SITE PLAN REVIEW AND APPEARANCE BOARD

---STAFF REPORT---

CITY OF DELRAY BEACH

ITEM: **Uptown Atlantic** – Class V Site Plan, Landscape Plan, Architectural Elevations and Waiver Approvals Associated With The Construction Of A Mixed Use Project That Contains 112 Dwelling Units, 17,267.30 square feet of office, 6,040 Square Feet of Restaurant, and 43,162 square feet of Commercial/Retail Floor Area Located Between SW 6th Avenue and SW 9th Avenue, South of West Atlantic Avenue.

LP-3
OF-6

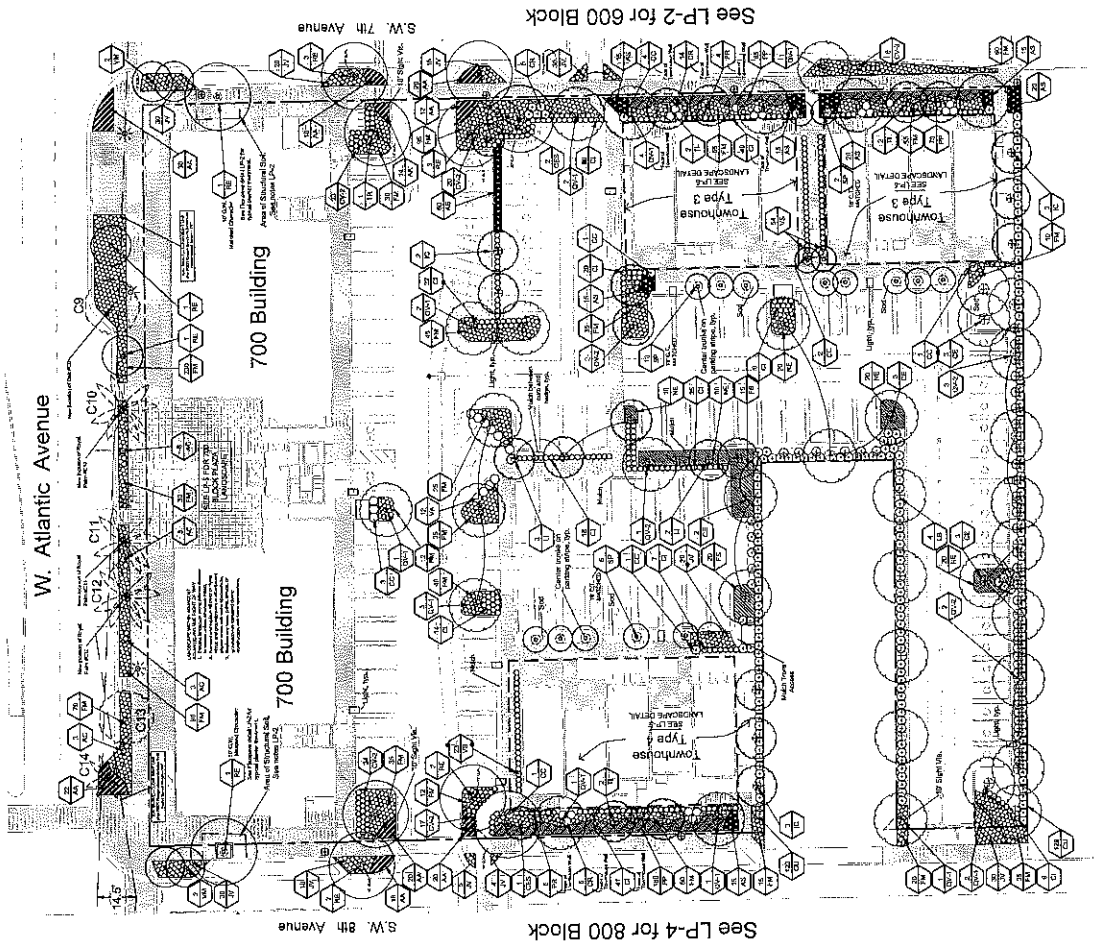
- 11) Sheet LP-3: The landscape island on the south side of the walkway and west side of type 3 townhome does not meet the width requirement.
- 12) Sheet LP-3: Per LDR 4.6.16(H)(3)(k), parking tiers are required to be separated by a landscape strip that is five feet (5') in width, exclusive of vehicular encroachment.
